# PERMIT

SEWAGE DISPOSAL SYSTEM  
HOWARD COUNTY HEALTH DEPARTMENT  
BUREAU OF ENVIRONMENTAL HEALTH  
410-313-2640

SUBDIVISION Farside LOT NUMBER 63 ADDRESS 11723 Fox Spur Court

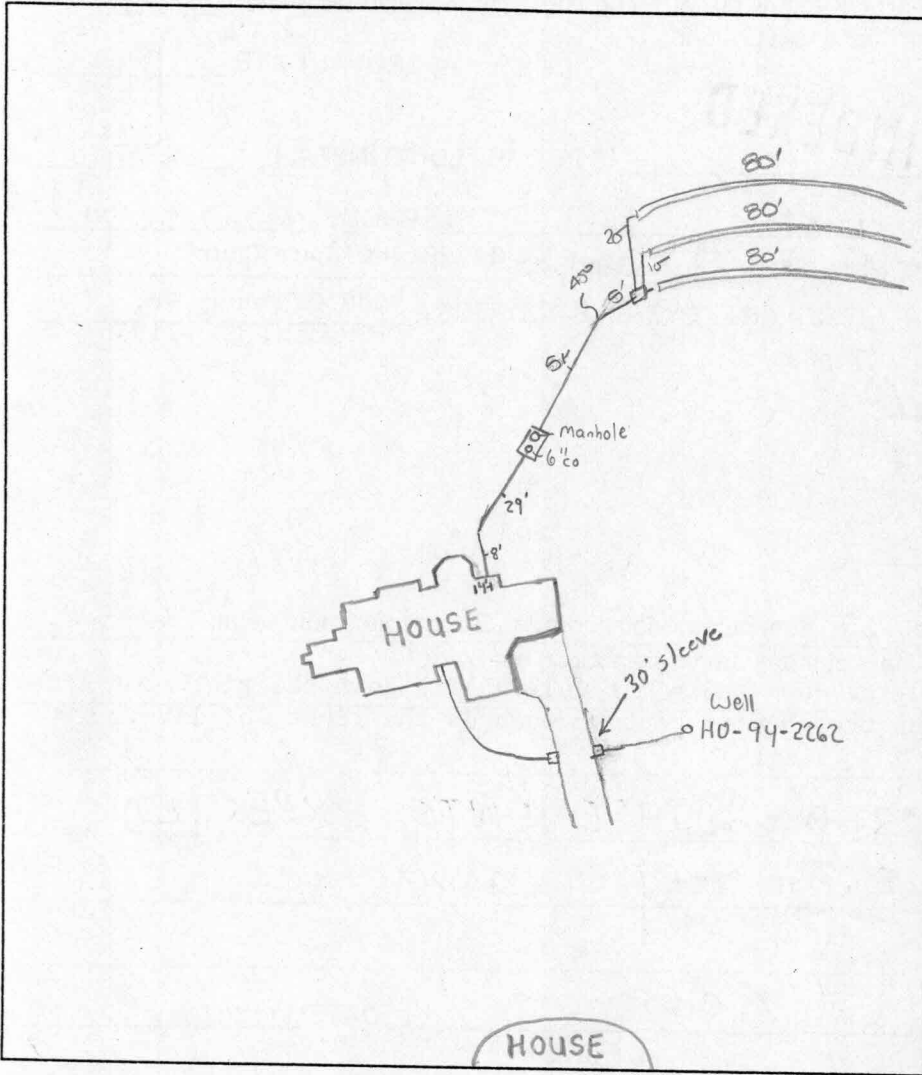
LAYOUT INSP. REQUIRED - ADJUSTMENTS EXPECTED  
WITH PIPE TO D. BOX FROM SEPTIC TANK

PRE-CONSTRUCTION INSPECTION: 5/4/01 - SEPTIC PIPING - (HOUSE SEWER) ADJUSTED SLIGHTLY AND FARTHER AWAY TO HELP ACCOMMODATE FOR FUTURE GRADING, FUTURE POOL LOCATION / TENNIS COURT & ASSOCIATED GRADING WILL HAVE TO BE ADJUSTED OVER TOWARDS THE 606.02 LOT LINE  
 INSPECTION COMMENTS: AS STATED ON THE APPROVED PERC CERT / BP PLAN, INSTALL TRENCHES TOWARDS THE D BOX SLIGHTLY OUT OF SDA AND RUN 3 TRENCHES ON CONTOUR (SR)

5/8/01 A.M. - OK to continue. DCC

5/8/01 P.M. FINAL INSP - OK to cover all septic work. DCC
